Proposed shop-top housing development (DA-482/2017)

59-75 Grafton Street, Bondi Junction

SUPPLEMENTARY STATEMENT OF ENVIRONMENTAL EFFECTS (Revision 1)

Submitted to Waverley Council

Figure 11 – Northern (Grafton Street) elevation: Comparison of Original DA (DA2300_A) and Amended DA (DA2300_D)

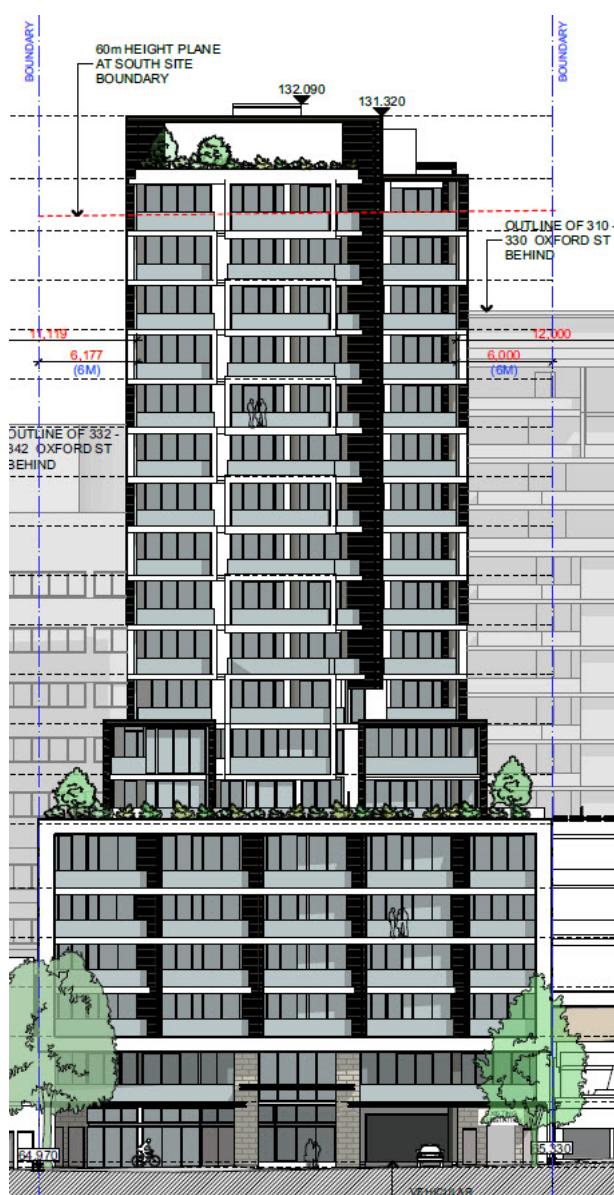
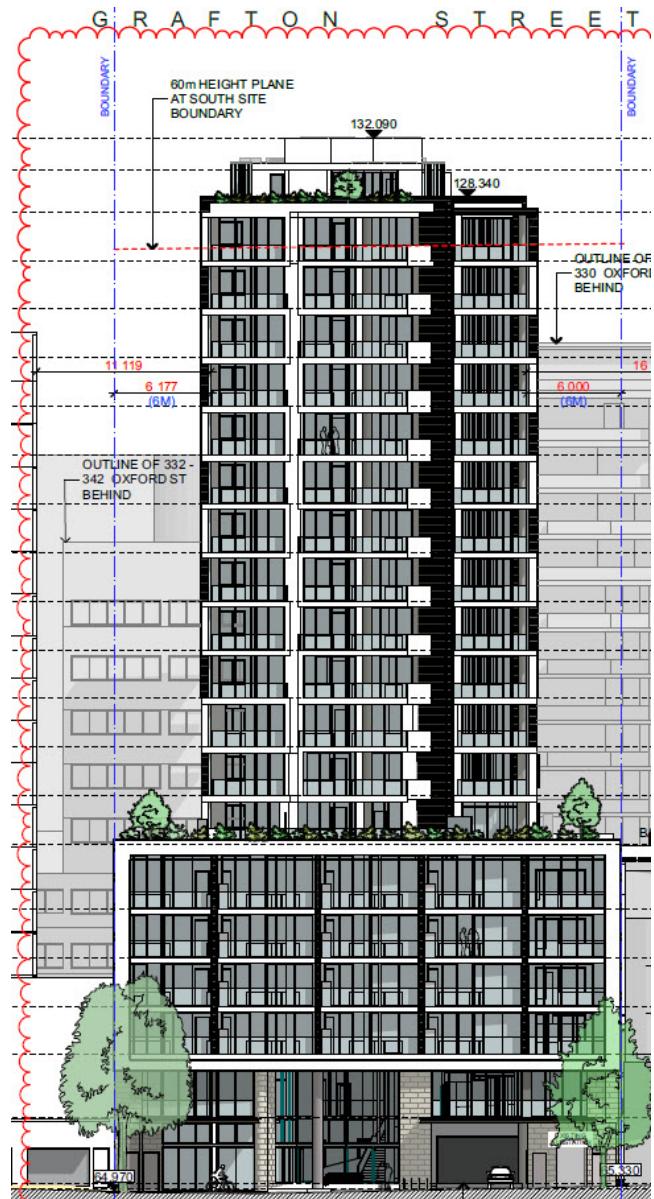
The Panel previously noted that the transition from the L5 podium to the tower form on both north and south elevations does not appear as well resolved as it might be. The Panel suggested the introduction of a recessive treatment and a more defined break between the two building elements. The current stepped wedding-cake form is not satisfactory. The Panel recommends that Levels 5 and 6 are reduced in area and the Level 5 terraces be reconfigured to create common outdoor space on the north-west corner for ease of access and minimal disruption to remaining units. It is understood that this area would need acoustic and wind treatment.

Steps in the building envelope between the podium and tower (referred to as a wedding cake form by the WDEP) have been removed to provide a simplified podium and tower form, as illustrated by **Figures 11** and **12** which compare the original and proposed north and south elevations.

Figure 12 – Southern (Hegarty Lane) elevation: Comparison of Original DA (DA2301_A) and Amended DA (DA2301_D)

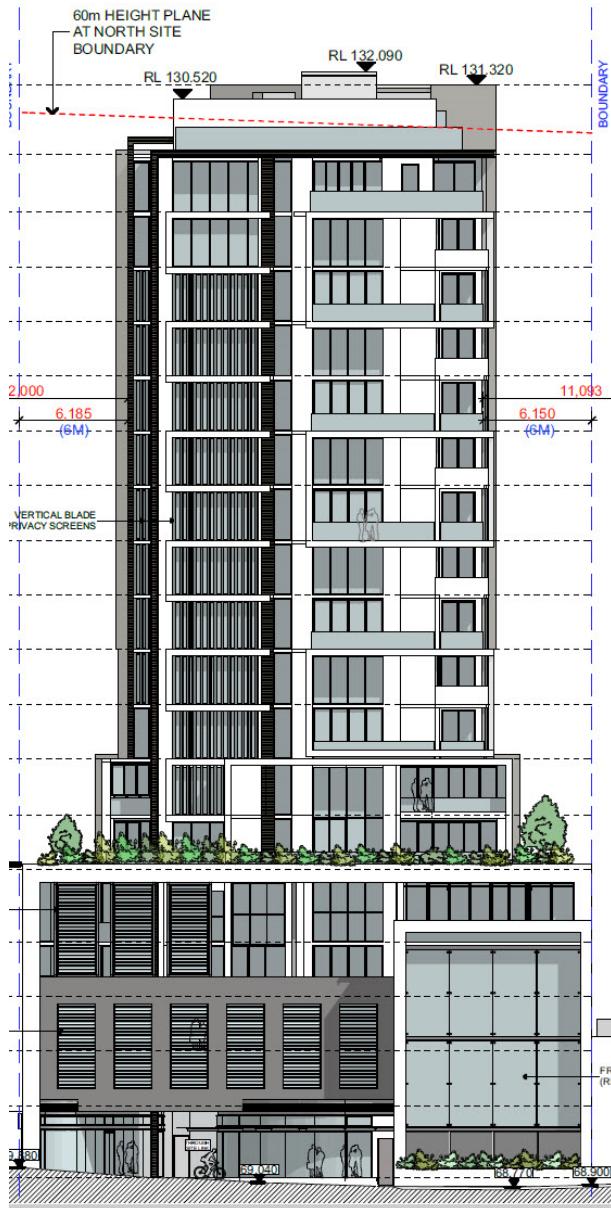
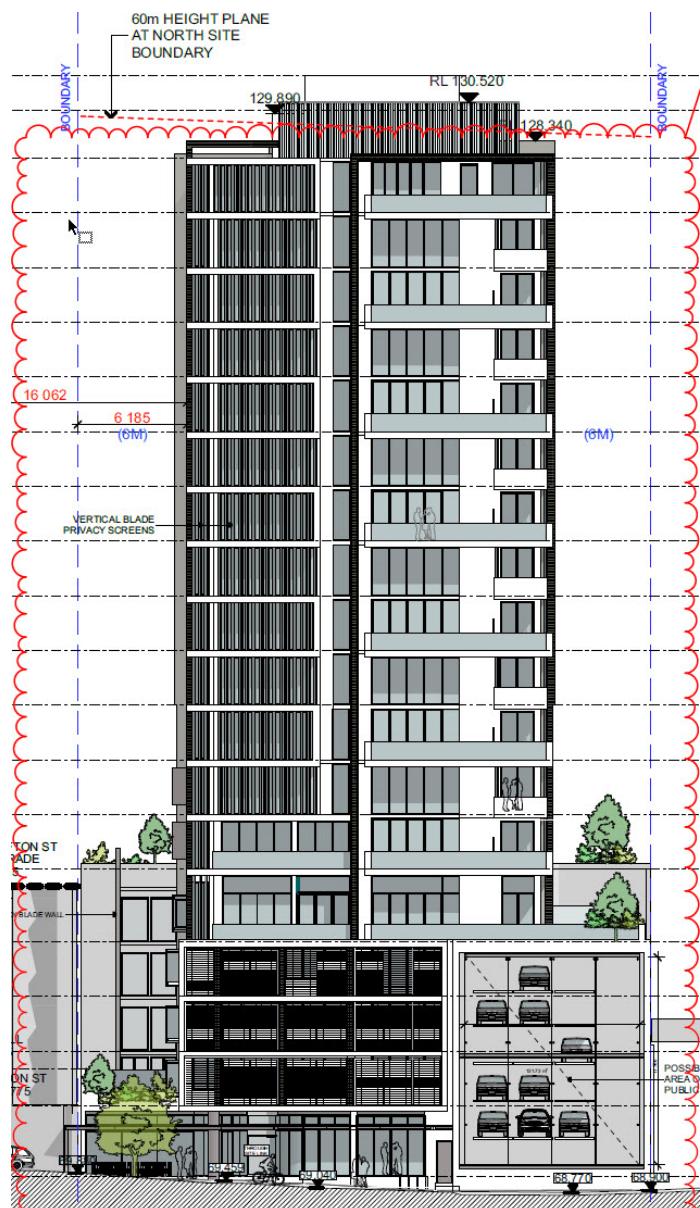
2. On the Hegarty Lane façade, the transition between the upper ground floor to level 1 is awkward with curved elements meeting with block edges above. It is suggested that a more integrated design be explored to ensure that this integral façade to the Lane can be executed to the desired aesthetic without the need for construction compromises later.

On the Hegarty Lane frontage the Panel was concerned about the built form relationship, and felt there needed to be a setback as discussed above and a scaling down of the elevation to create a more complementary relationship with the public domain and buildings opposite. This would be helped by limiting the podium height to 4 storeys (Ground + 3) instead of 5, and reconsideration of the framing to the car stacker mechanism to reduce its bulk and visual domination in the lane. Consideration should be given to applying the Level 5 plan to Level 4 in terms of the setback from the eastern side boundary and Hegarty Lane, modifying or deleting the Type 1 apartment on Level 4. The massive blade between the Type A and Type B apartments on Levels 3 and 4 should be deleted. A consistent elevation of glass louvred balconies should about the mechanical car stacker. The current frame on the stacker should be deleted and the proposed artwork should be considered in a number of ways, including treating the whole as an art object.

The amended Hegarty Lane podium design has been reduced in height by one storey (now ground plus three storeys) and the overall southern façade has been simplified to address the WDEP comments, as illustrated by **Figures 9, 10 and 12** which compare the original and proposed Hegarty Lane photomontages and elevations.

The frames around the mechanical car parking system and southern façade blade have also been reduced in scale.

Figure 2 Floor Mounts

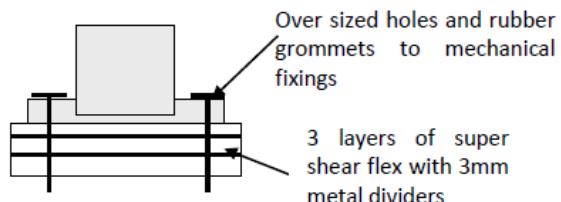
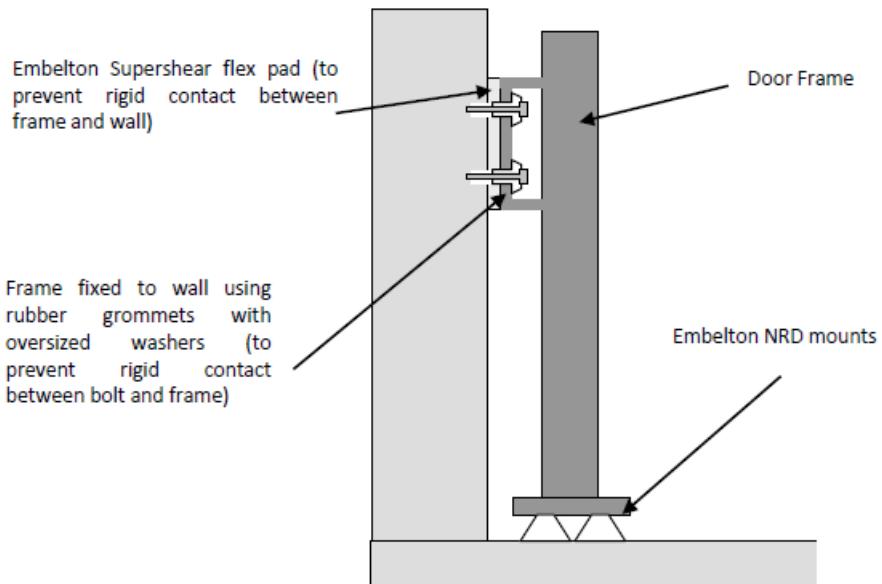
1. The SEE and traffic statement state that 75 resident car and 10 commercial/retail car parking spaces are provided in the development, however the figures shown on the plan for the car stacker indicate that 86 car parking spaces are proposed. Any surplus parking above Council's DCP rate (which is considered the maximum) is not supported.
2. The proposed paving treatment across Hegarty Lane is not supported as a part of this DA, as it is outside the property boundary. Any modification to the road surface will require traffic engineers input and approval from Creating Waverley.
3. Although a specification of the proposed car stacker system was submitted, further clarification is required regarding its operation including details of manoeuvrability, (ie. in and out in a forward direction?) location of any associated plant and noise impacts from the mechanics.

3. The turntable lift and traverse (car hoist) shall be resiliently mounted from the building structure to ensure vibration levels are attenuated from the surrounding buildings and within the building. No mechanical connection between the building and the car stacker/hoist is permitted at any location.

4. Floor Mounts need to be three layers of Super Shear Flex with sheet metal dividers and rubber grommets to mechanical fixings (figure 2). The hold down bolts shall be passed through the RHD mounts and washer and nut applied on top. The bolts shall not be over tightened to ensure that they do not over-compress the mount.
